Reference: Schedule 2 – Part B

Project Approval Condition	Project Approval Description
B38	HERITAGE – MINIMISING IMPACTS The Applicant shall prepare detailed elevation and window plans for the Royal Hall of Industries in consultation with Heritage NSW and Council (or its delegate) demonstrating how the proposal will minimise heritage impacts to the greatest extent practicable. Evidence of endorsement by Heritage NSW must be submitted to the Secretary.

In Response to Condition B38 of Schedule 2 – Part B. The following Drawings SK.03.0020 and AT.75.0003 have been prepared by Populous and Urbis Heritage to demonstrate the proposed strategy for minimising heritage impacts to existing windows and doorways. The following principles will be adhered to for all existing windows and openings:

1 RHI TYPICAL GROUND FLOOR WINDOW
1:10

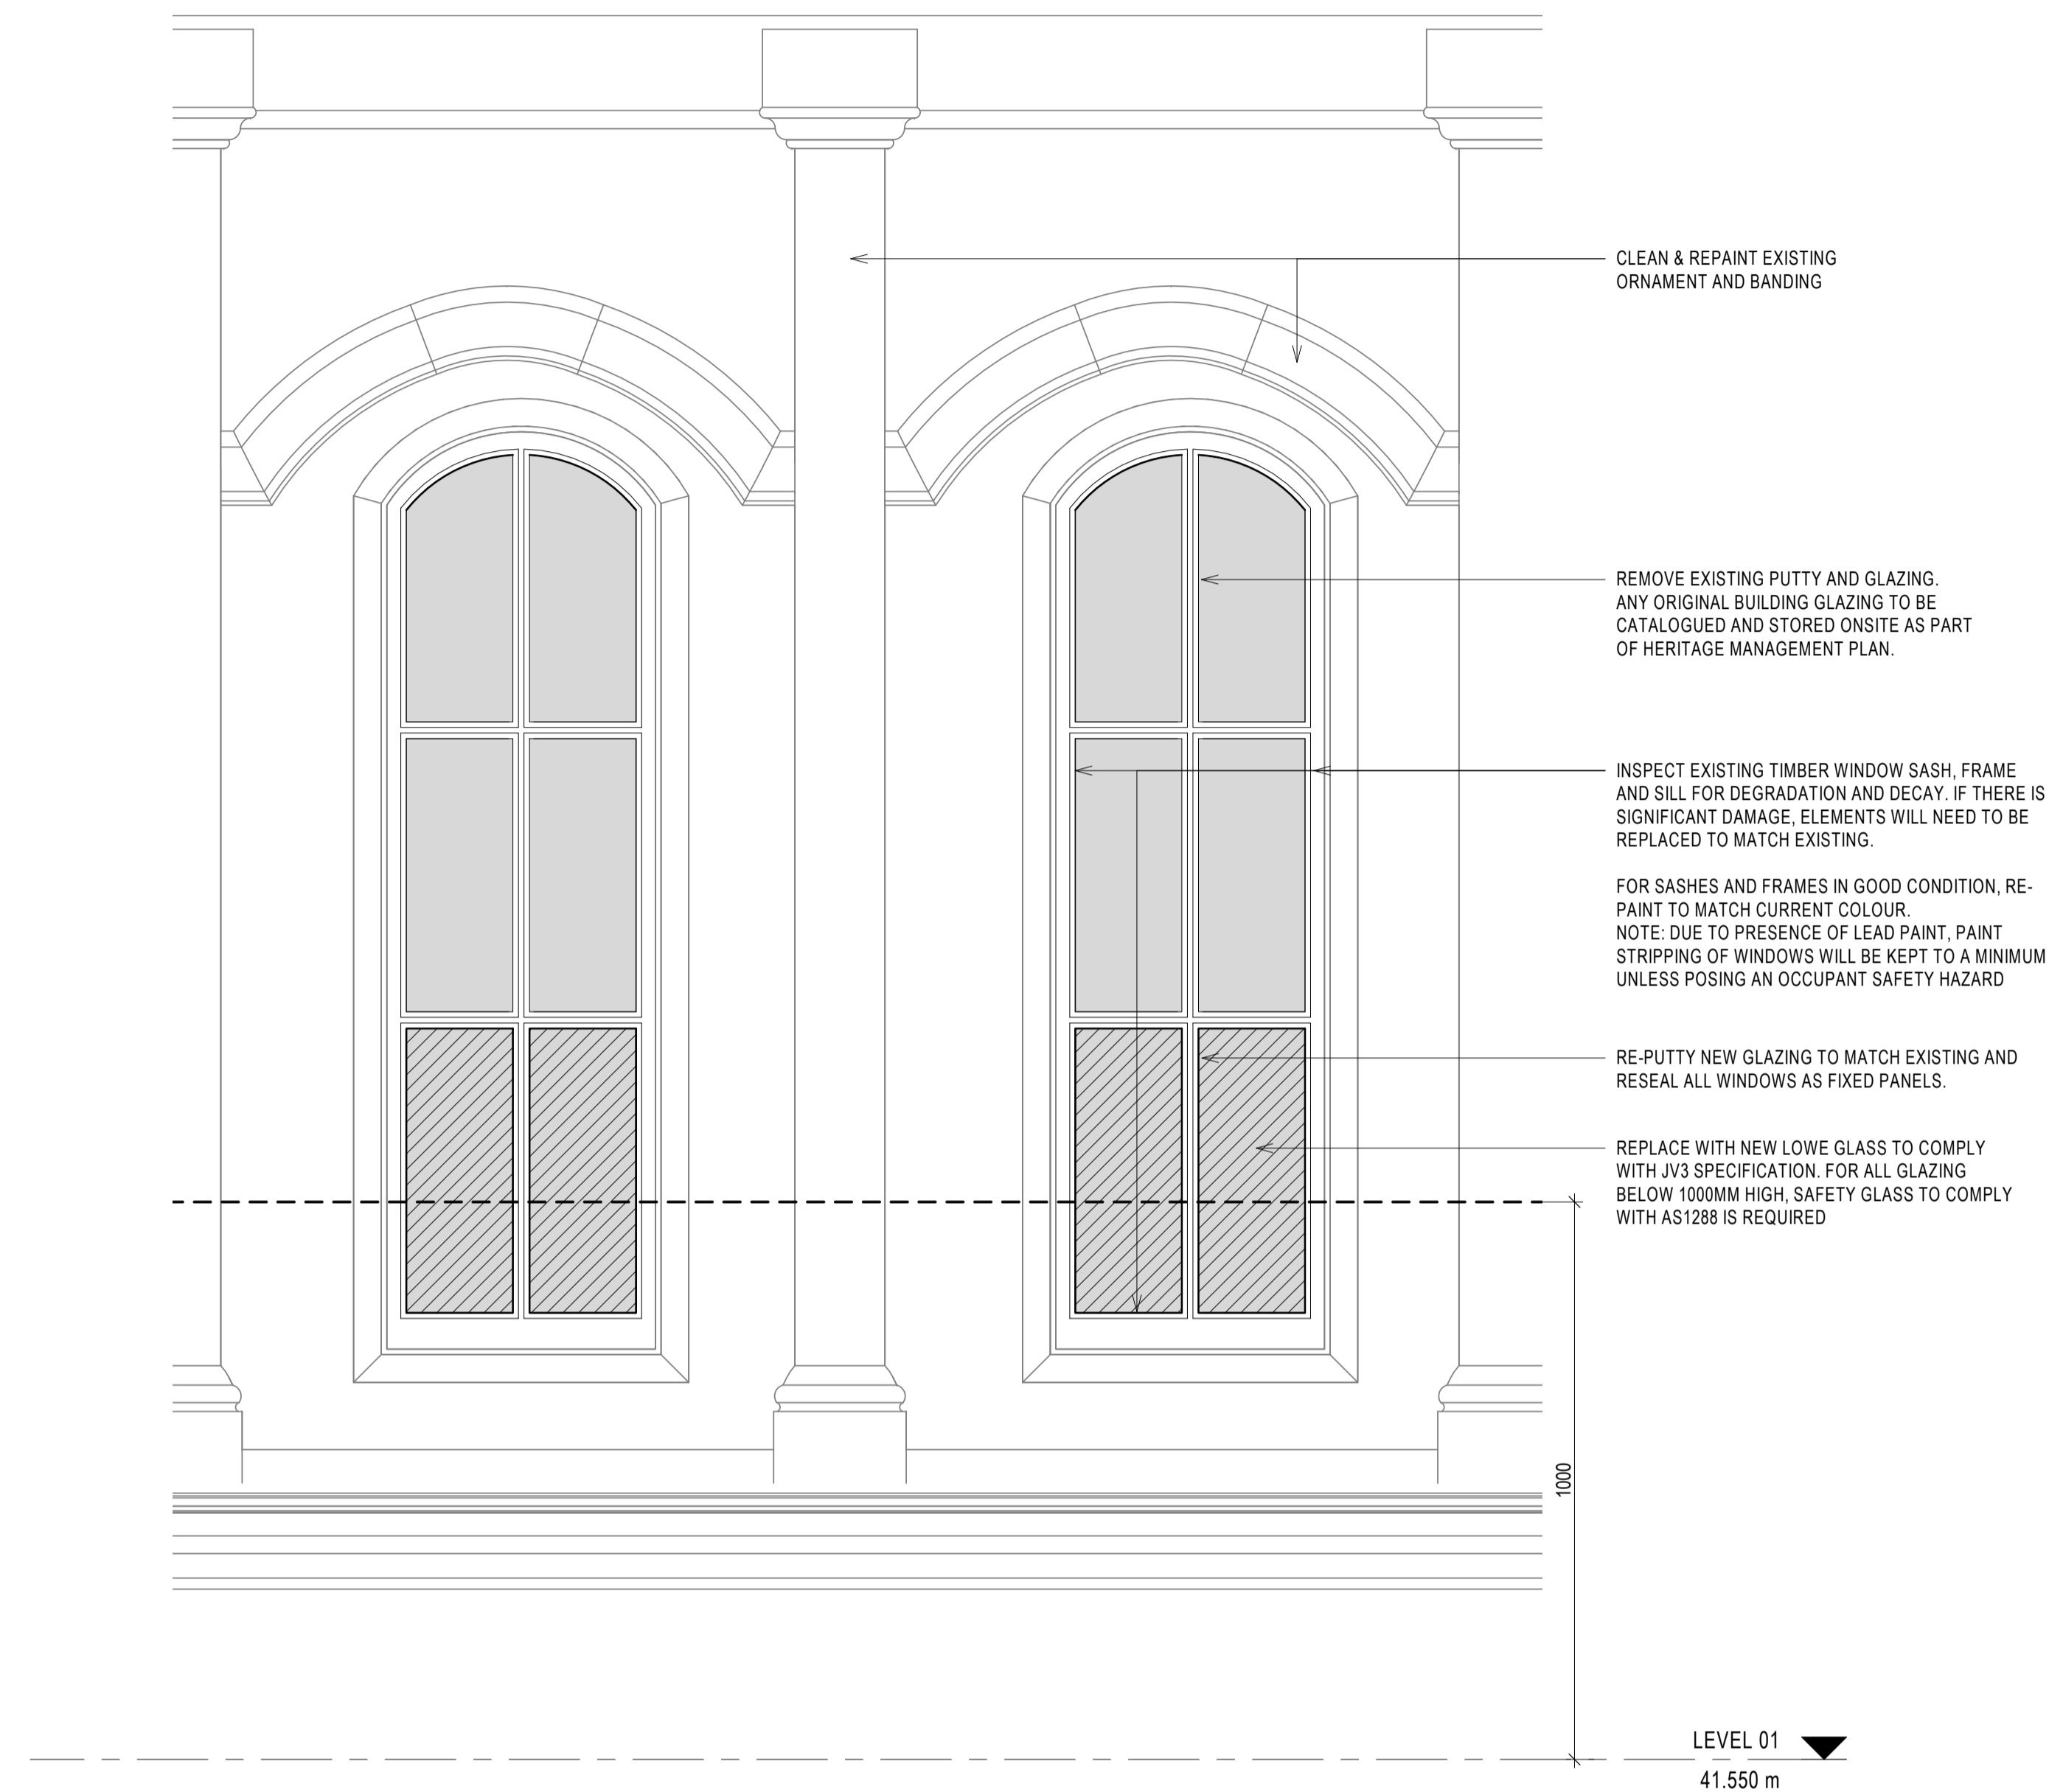
1. Existing Heritage Windows (Refer Drawing SK.03.0020)
 - Remove existing putty and glazing. Any original building glazing to be catalogued and stored onsite as part of Heritage management plan.
 - Each existing timber window sash, frame and sill will be assessed for degradation and decay. If there is significant damage, elements will need to be replaced to match existing.
 - For sashes and frames in good condition. Repaint to match current colour. Note; due to the presence of lead paint, windows will only be stripped where absolutely necessary for occupant safety.
 - Replace with new LowE glass to comply with JV3 specification. For all glazing below 1000mm high, safety glass to comply with AS1288 is required
 - Re-putty new glazing and reseal all windows as fixed panels.

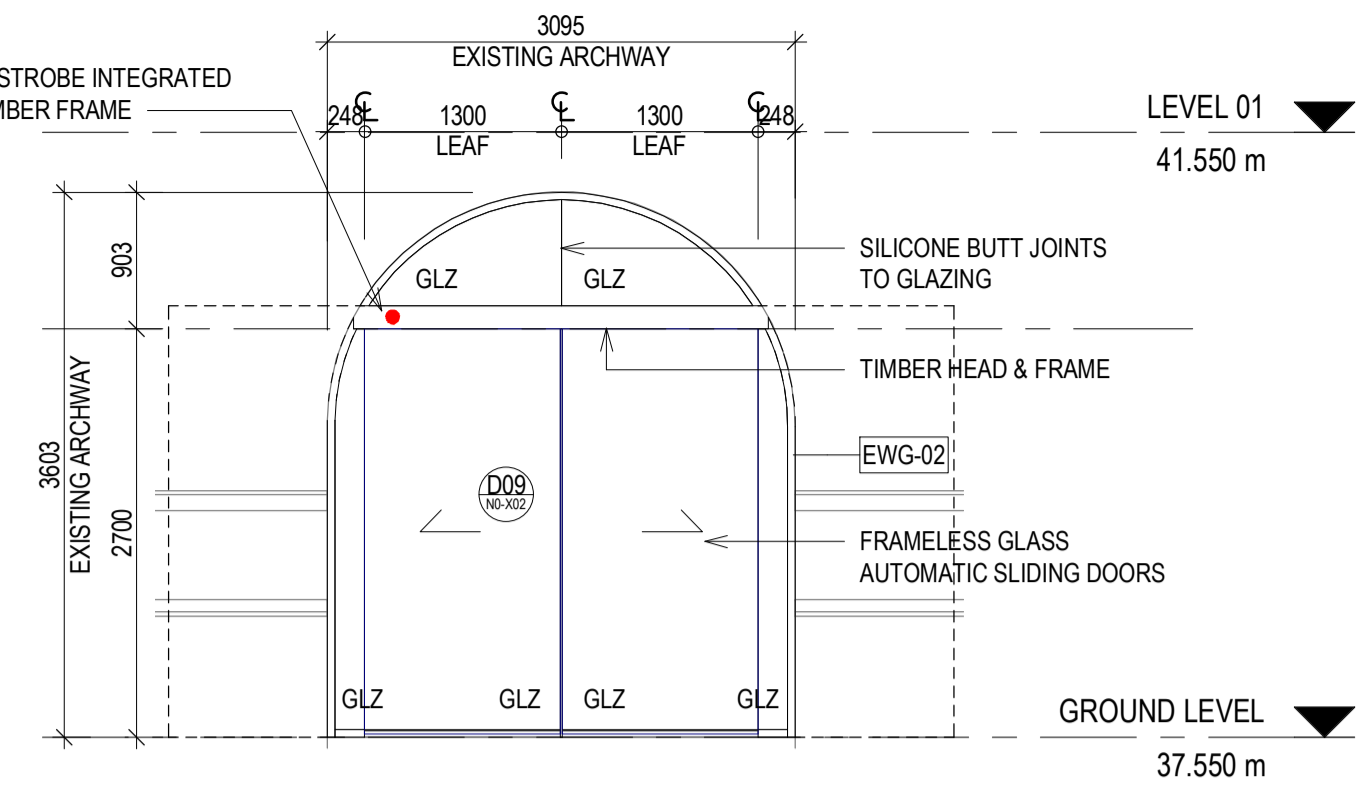
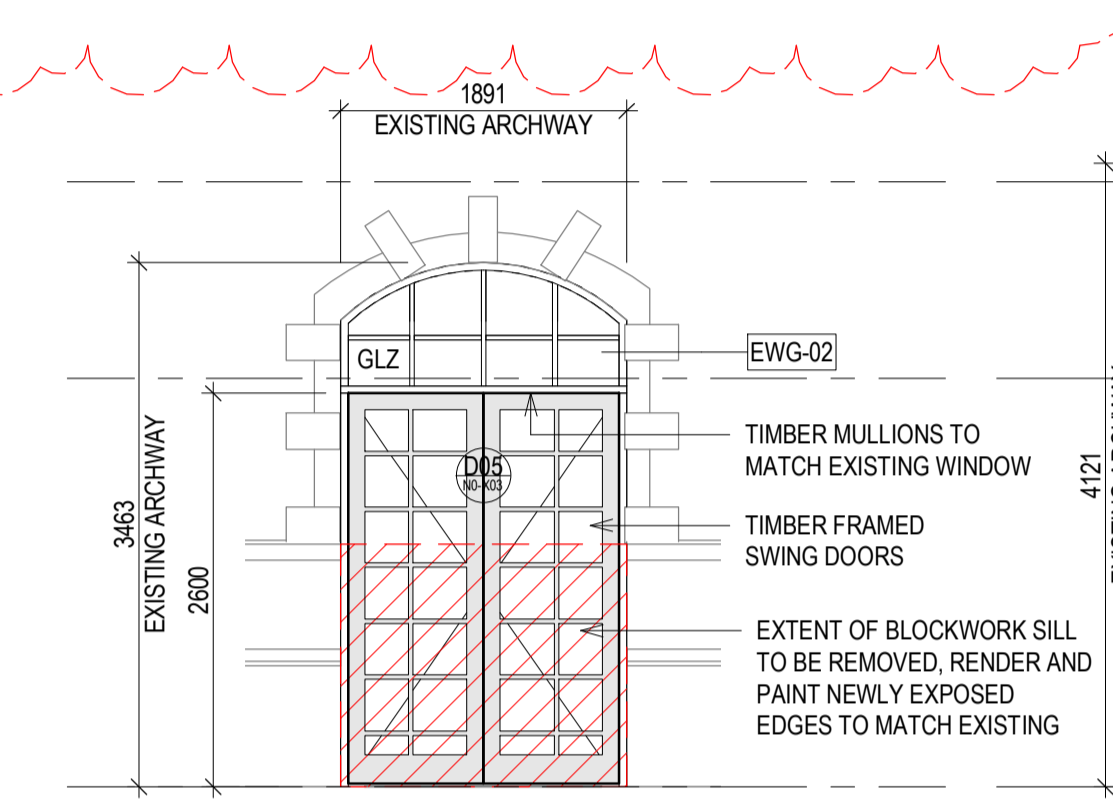
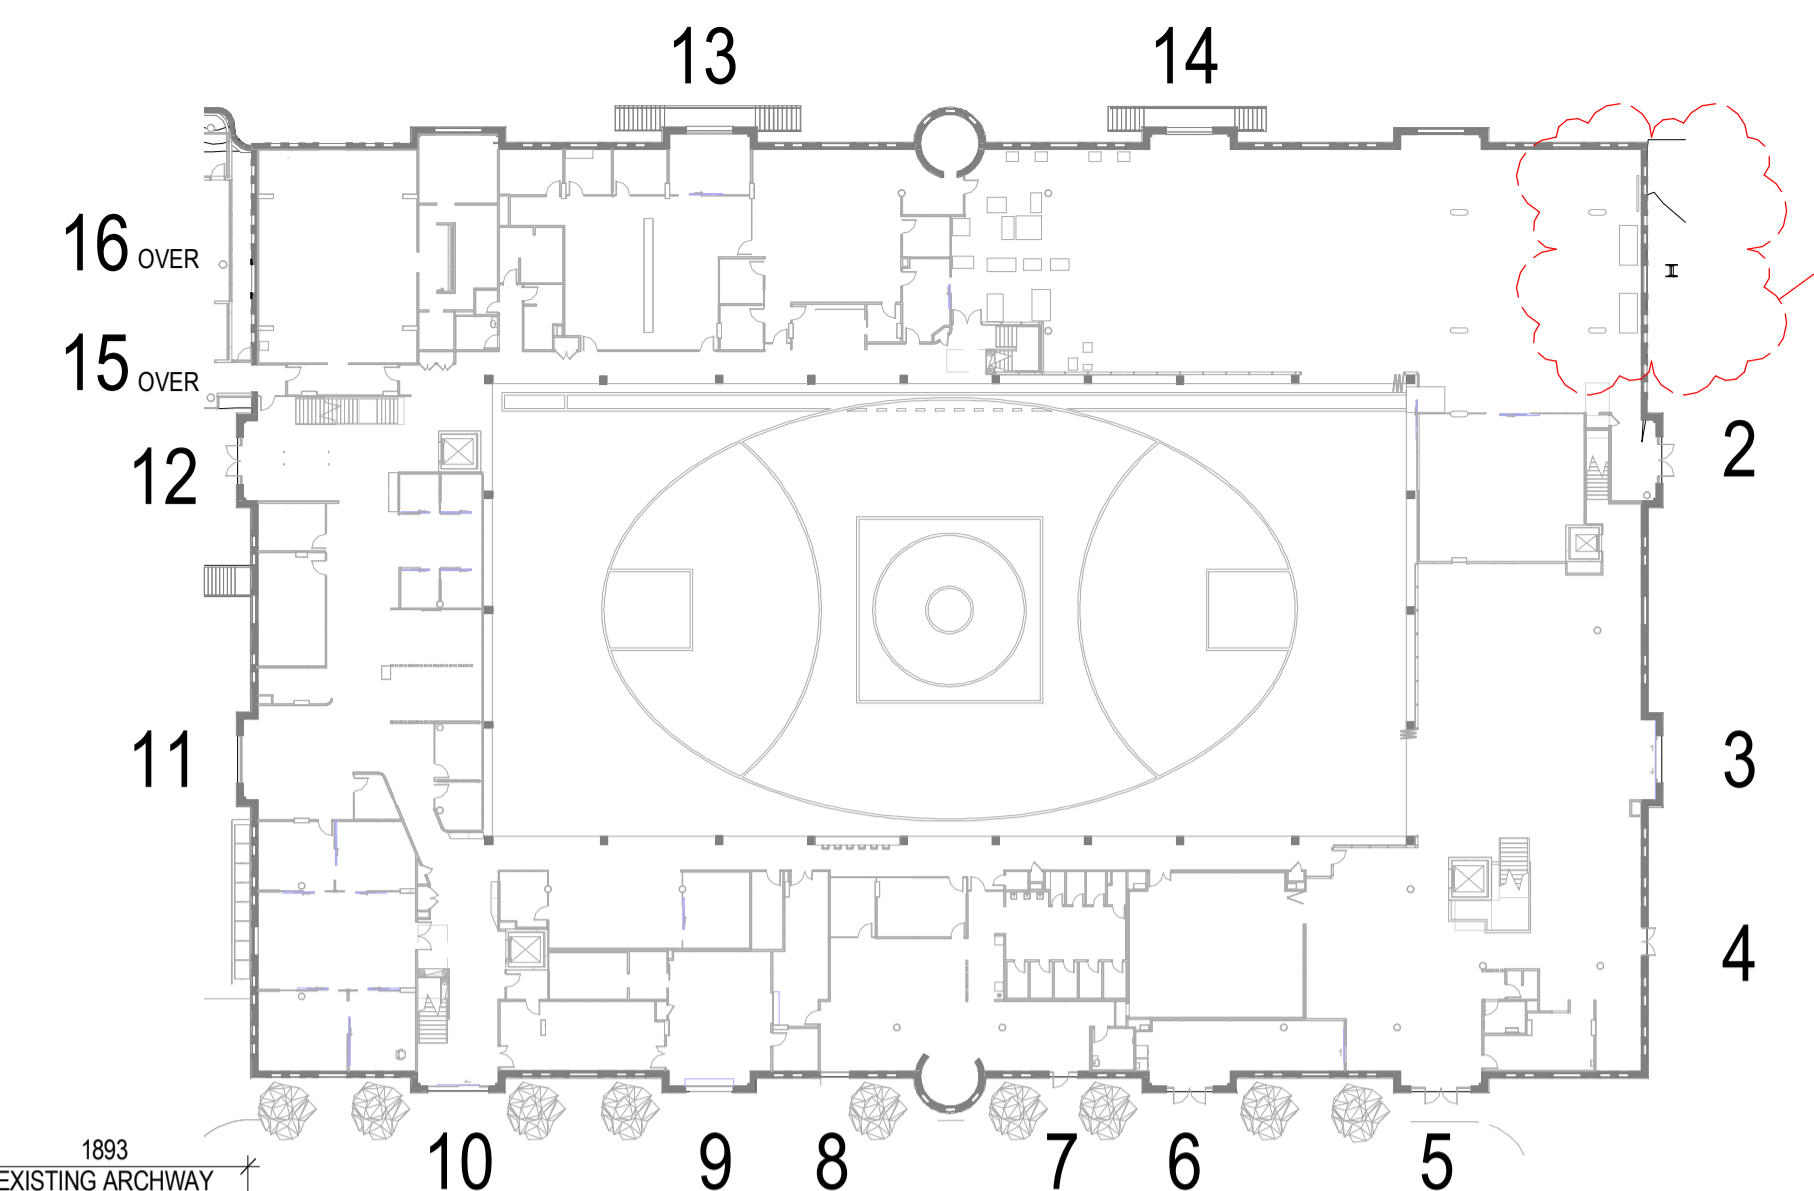
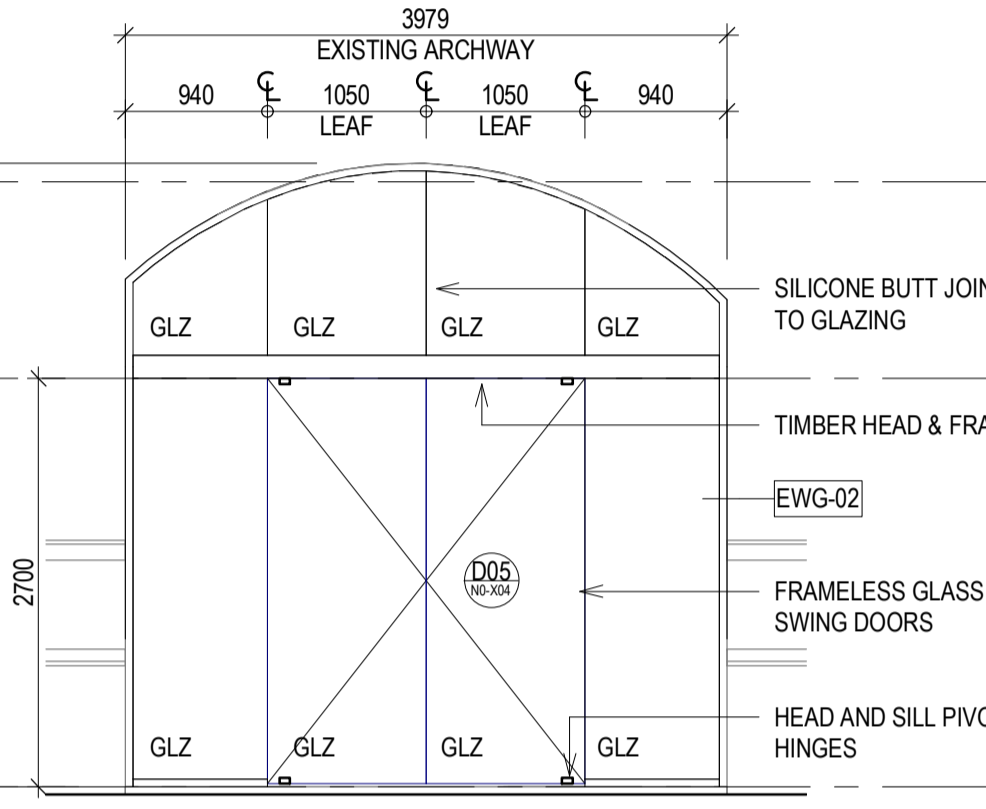
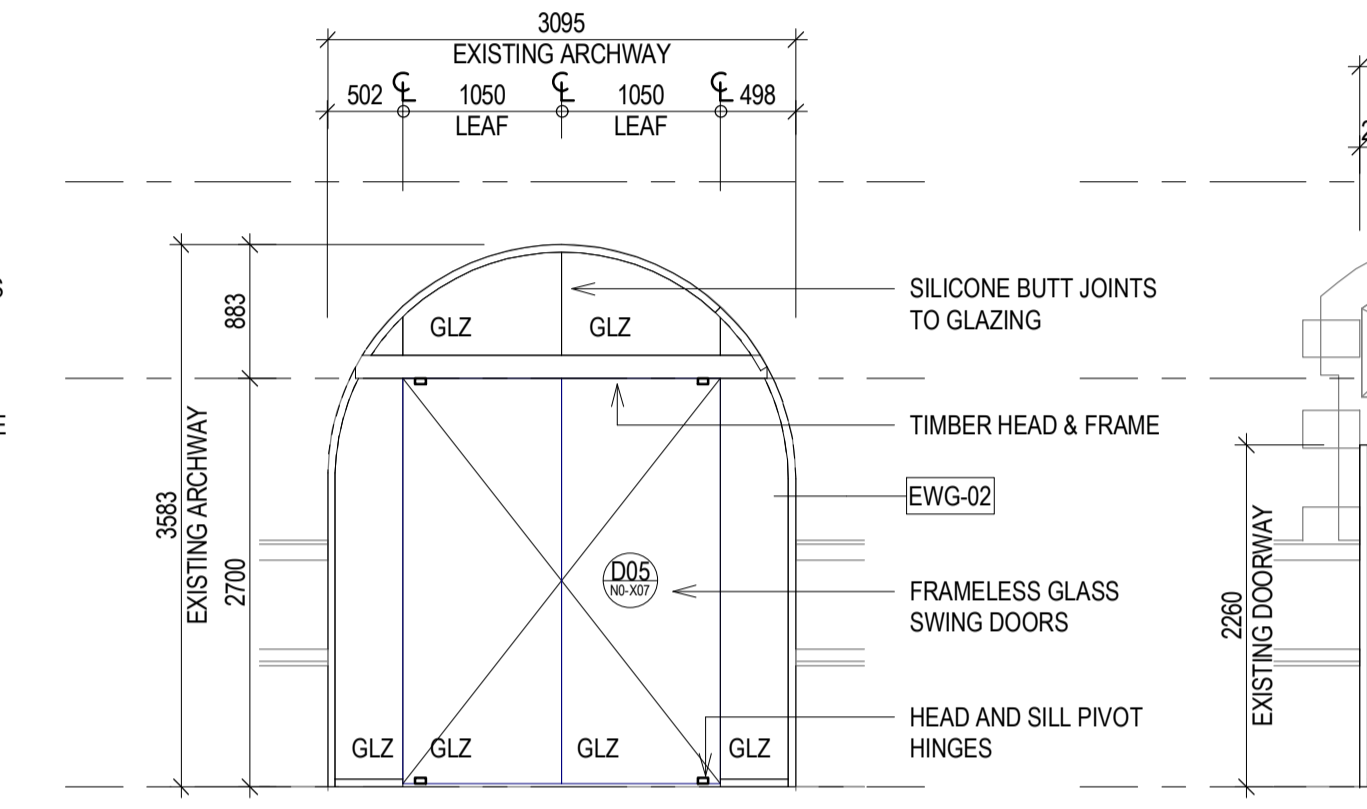
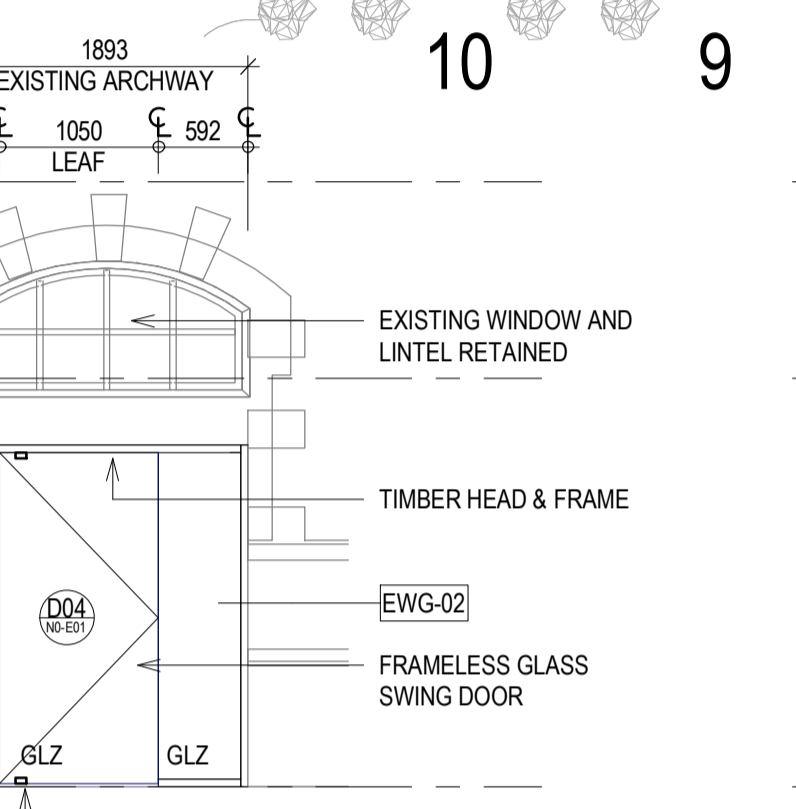
2. Existing Doorways (Refer Drawing AT.75.0003)
 - The existing entrance doors are contemporary and are not significant. They will be removed and opening repaired and made good, ready for new door suite.
 - New hardwood framed arched doorways and fixed glass panels to be installed in Brickwork openings. New timber frames will be clear seal coated to delineate new works from the original painted heritage windows.
 - Patch and repair internal render to line of new Frame.

3. New modified openings (Refer Drawing AT.75.0003 – Details 4,15,16)
- The RHI propose three (3) modifications to the existing brickwork fabric for new openings. These involve the partial removal of brickwork to expand existing window openings to create doorways.
 - For each opening, saw cut and remove existing brickwork as required for opening size. All existing brickwork and removed windows are to be cleaned, catalogued, and stored onsite, for reuse in the event of future patch and repairs, as part of Heritage management plan.
 - Apply 13mm render finish to inner face of cut brickwork to make good opening modifications
 - New hardwood framed doorways and fixed glass panels to be installed in new Brickwork opening. New timber frames will be clear seal coated to delineate new works from the original painted heritage windows.
